Volare Carburetors LLC

Service Bulletin: SB-13

SUBJECT - ACCELERATOR PUMP PLUNGER

FIGURE 1

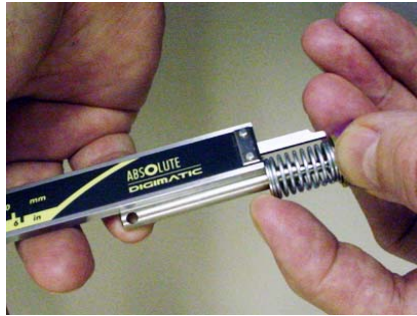
- The dimension from the top of the pin retaining washer to the top of the brass skirt back-up washer must be at least .730 inches (18.5 mm), see Figure 1.

FIGURE 4

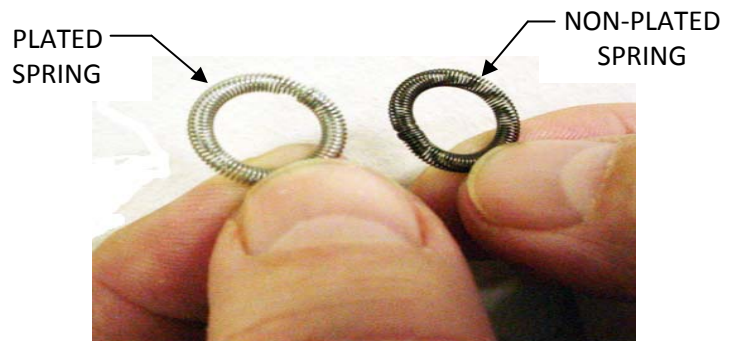
- c. Plungers must be at least 2.620 inches (66.5 mm) long, see Figure 3. (Do not measure over the upset end of the stem at the center of the piston.)
 - d. The skirt spring must be plated, see Figure 4. Plated spring, left, is bright, silver colored. Non-plated spring, right, is blue/black.
